GLOBAL SAFETY FIELD INVESTIGATIONS
DCS5740
URGENT - DISTRIBUTE IMMEDIATELY

Subject: REVISION – N202325460-01 - Service Update
Radio Software Update
Revised the service procedure and the warranty information table.

Models: 2021 Cadillac Escalade and Escalade ESV

N202325460 Radio Software Update

5766434

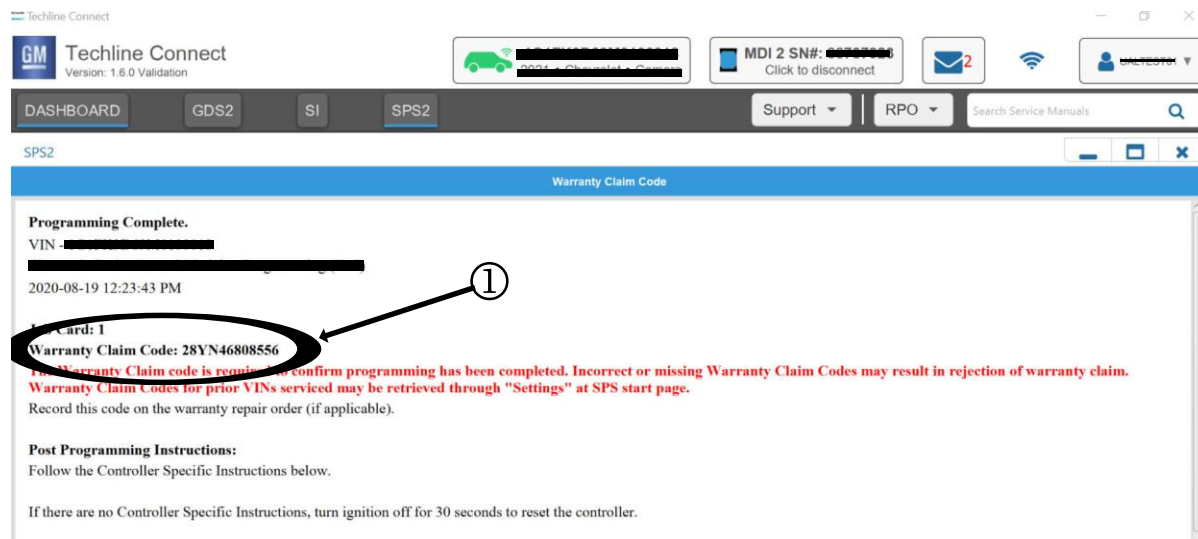
Important: It is important to ensure that the technician is inspecting the full information found within *Build Number*. To identify the current software installed in the radio requires the user to locate the *Build Number* to view the full software version file name. In the middle of this long file name look for 382. (The illustration below shows software version 377, thus that would be outdated.) The number would be numerically lower if the radio is not up to date, or numerically higher if newer versions were released and installed.

1. Inspect the current radio software version. Navigate to Settings -> About -> Build Number to view and verify the software version.
 - If equal or greater than 382, this bulletin does not apply. Refer to SI for diagnostics.
 - If less than 382, update the radio software via USB. Refer to A11 Radio: Programming and Setup in SI.
2. Reprogram the Radio. Refer to *A11 Radio: Programming and Setup* in SI.
